RESPONSE TO SUBMISSIONS (BUILT HERITAGE)

LINDFIELD LEARNING VILLAGE

RESPONSE TO SUBMISSIONS (BUILT HERITAGE) - LINDFIELD LEARNING VILLAGE

Picture 1 – Proposed site plan showing trees to be removed in red.

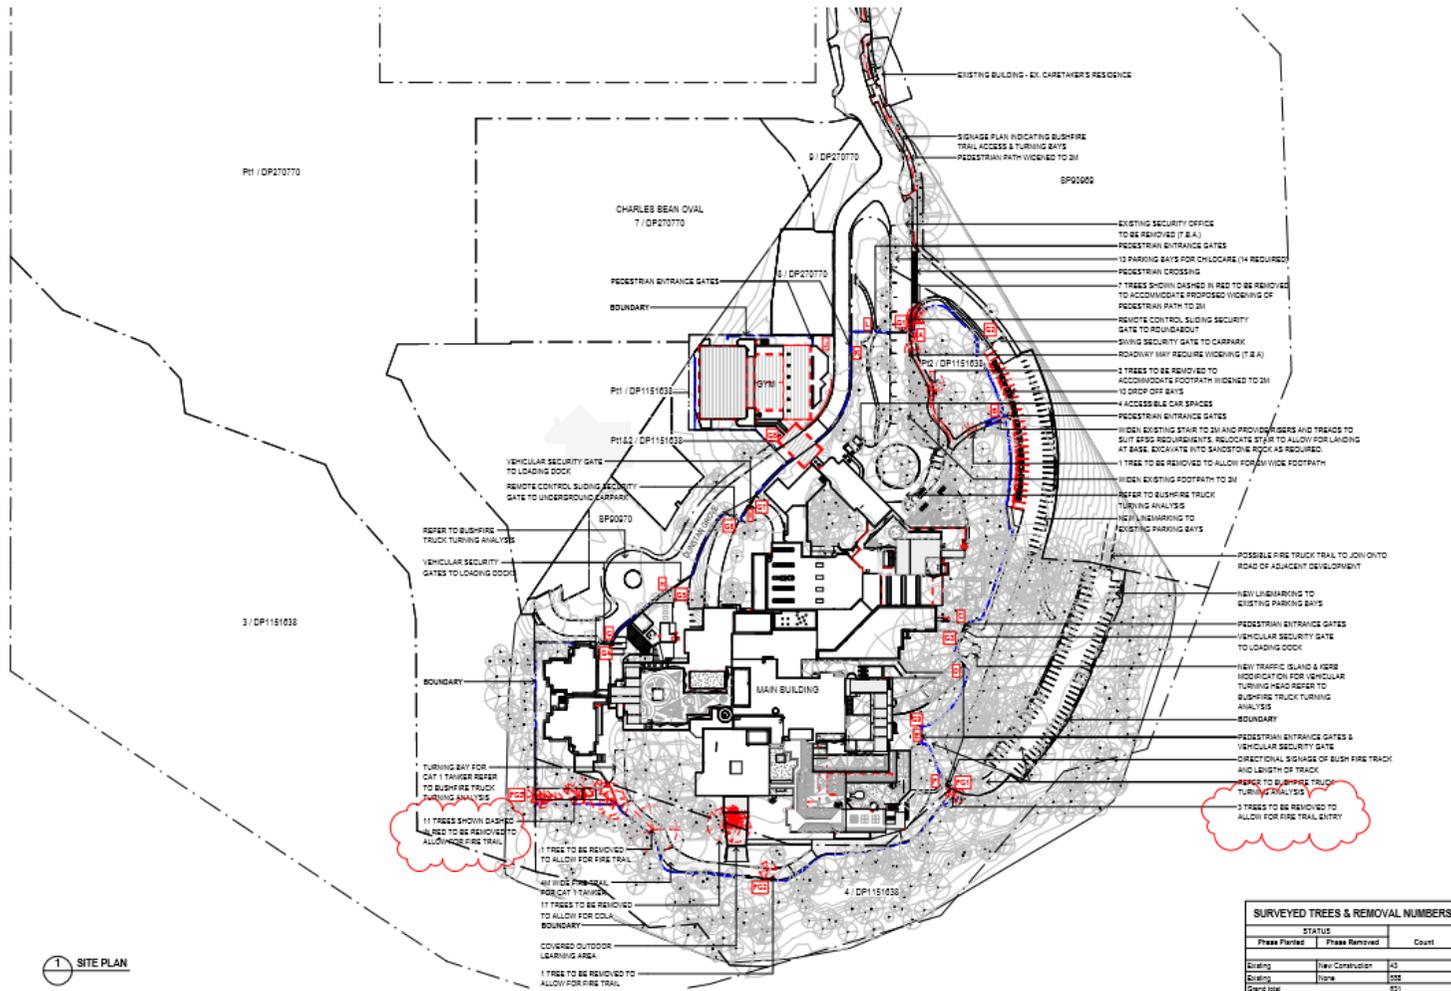
5.11.2 The advice of a landscape architect and the heritage consultant for the project be sought if fire fighting vehicle access routes are required.

The bushfire response has been designed to allow for minimal removal of trees while still allowing for the building to be continually used. It is understood that without the stipulated bushfire precautions that the habitation of the building would not be possible.

The site plan reproduced below indicates a total of 43 trees around the site to be removed. This plan is the result of consultation between the heritage consultant, bushfire engineer, landscape architect and biodiversity consultant. It is understood that this is the minimum number of trees required to be removed to allow for the place to function as a school. The removal of trees would allow for a fire trail, widening of pedestrian paths and the construction of the COLA to the south of the existing building. The bushfire engineer has advised that a 3m buffer around the security fence as previously noted in the EIS is not required and that the fire trail along the southern fenceline is a sufficient buffer.

It is appreciated that areas for tree removal are dispersed around the site. There is no one area where the natural setting would be drastically changed. Further, no removal of trees would occur in the natural bush setting beyond the proposed fencing. As such, the impact on the natural setting is confined to the area in the immediate setting of the building, the density of the vegetation beyond the definable curtilage of the school. Even so, a large number of native trees within the bounds of the school would be retained. The surveyed trees and number identified for removal (as shown on the drawings) indicates that for the 43 trees that are to be removed there are 595 within the site which will

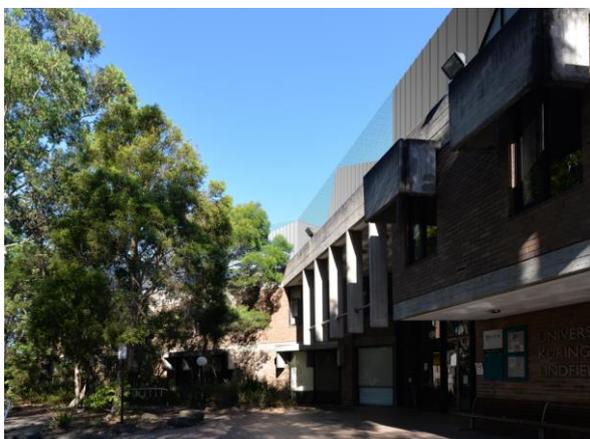
5.11.12 The proposed additional of an extra storey near the main entry for a new childcare centre should be screened from the approach and entry by appropriate native plantings in rooftop planter boxes.

There was not an opportunity to introduce planter boxes along the boundary of the additional storey above the main entry. However, as shown in the images below the previously proposed application of bright colours to this addition has been revised such that there is a tonal relationship between the addition and the original building, and the addition is more recessive in the context of the entry.

Picture 8 – Proposed alterations to the bus bay.

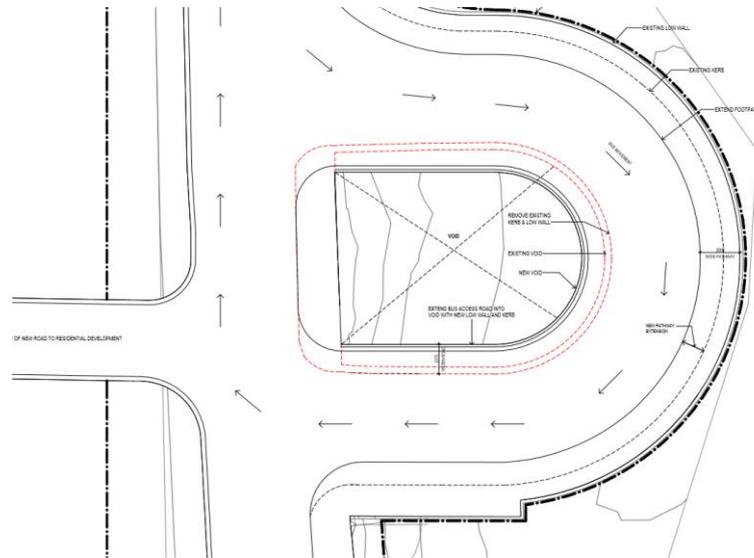
The changes to the design of the bus bay have been revised and now involve alterations to the existing void to allow sufficient clearances for 14.5m buses and to accommodate a 3m walkway and queuing zone for pedestrians.

The Eton Road Bus Bay is identified in the accompanying document as a highly significant item. The traffic solutions have been designed with direct reference to the significance of the bus bay. The central void with native landscaping would be retained however it would be made smaller to allow for the swept path of 14.5m buses (refer image below). Even so, the shape of the void would be retained and the concrete balustrade would be reconstructed to bound the new void.

It is understood that the landscaped area surrounding the bus bay has not been surveyed at this point for the purpose of determining how many trees would need to be removed. The landscaping solution for the void within the bus bay should be addressed in an Implementation Plan which must ensure protection of the significant species in the context of the reduced void size. This may require arborist input.

It is understood that alterations are required to the awning surrounding the bus bay to cover the widened footpath. The design of the new awning has not been resolved at this stage, with discussions with Council ongoing. As the existing awning is in keeping with the character of the place, the design resolution of this element should be addressed in an Implementation Strategy which must stipulate the retention of the half height concrete wall bounding the outside of the bus bay. The new awning must extend from the retained concrete wall.
